LINE	QUANTITY	UOP	CAT NO	ITEM NUMBER	UNIT PRICE	AMOUNT
				ADDENDUM NO. 2		
				THIS ADDENDUM IS ISSUED TO:		
				1.) ADD THE FOLLOWING DOCUMENTS		
				GSD096430 ADDITIONS/CHANGES TO SPECIFICATIONS		
				GSD096430 SECTION 00300 BID FORM (REVISED)		
				GSD096430 SECTION 01100 SUMMARY OF WORK (REVISED)		
				GSD096430 SECTION 05500 METAL FABRICATION		
				GSD096430 SECTION 08110 STEEL DOORS		
				GSD096430 SUPPLEMENTAL DRAWING AD-X1		
				GSD096430 SUPPLEMENTAL DRAWING AD-X2		
				GSD096430 SUPPLEMENTAL DRAWING AD-X3		
				GSD096430 STAGING LOCATION DRAWING		
				2.) EXTEND THE BID OPENING DATE:		
				BID OPENING DATE IS EXTENDED TO: 05/07/2009		
				BID OPENING TIME REMAINS: 1:30 PM		
				***** END ADDENDUM NO. 2 *****		
0001		JB		910-66		
	1			REROOFING OF BLDGS #5, 6 & 7, STATE CAPITOL COMPLEX

## ADDENDUM NO. 2

RE: Roof Replacement  
 State Office Building Nos. 5,6, &7  
 West Virginia Capitol Complex  
 Charleston, West Virginia  
 Architect's Project No. 0812

DWG. NO.  
**AD-X2**

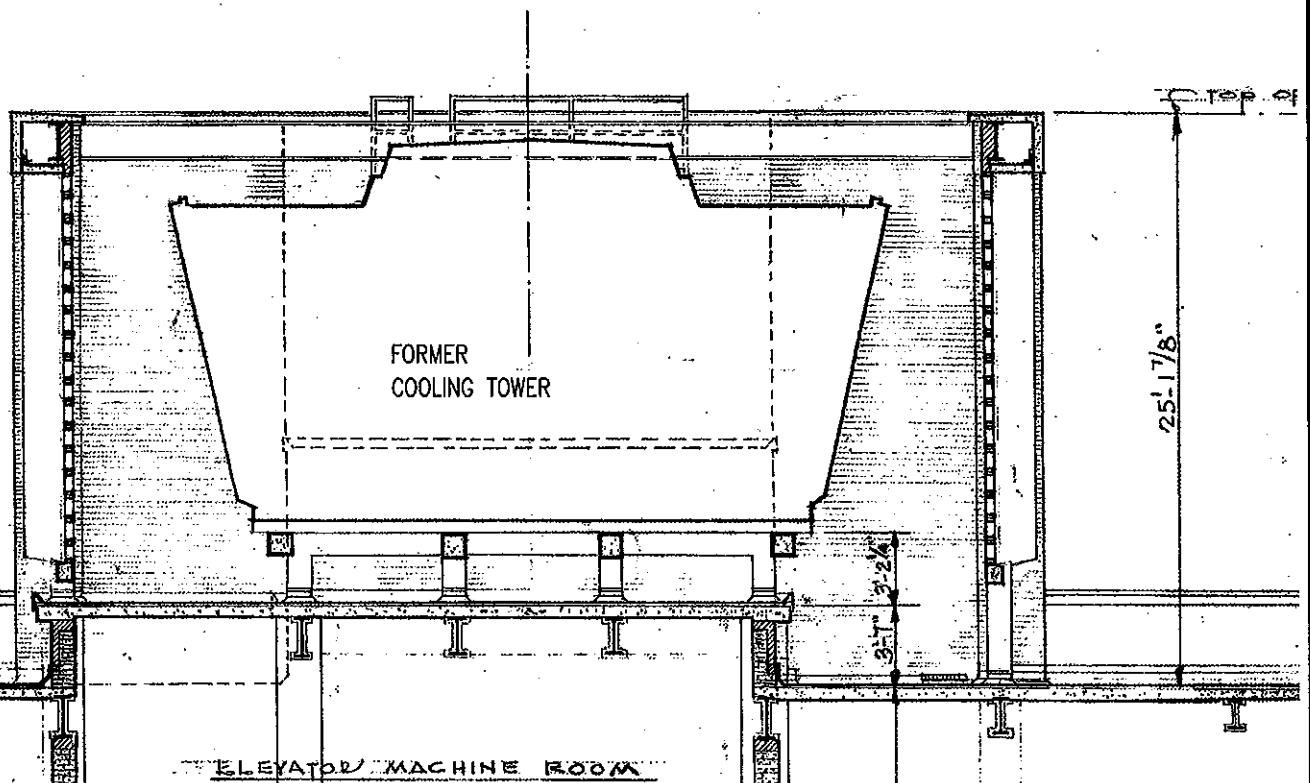
1. See revised drawing nos. AD-X1, AD-X2, and AD-X3 as attached to this Addendum.
2. Drawing AD-1 – Make the following revisions:
  - A. ADD note to two items tagged Keyed Note 12 at western edge of stairwell to read: "Communication equipment to remain active during construction. Contractor to protect equipment and communications cables during demolition and construction."
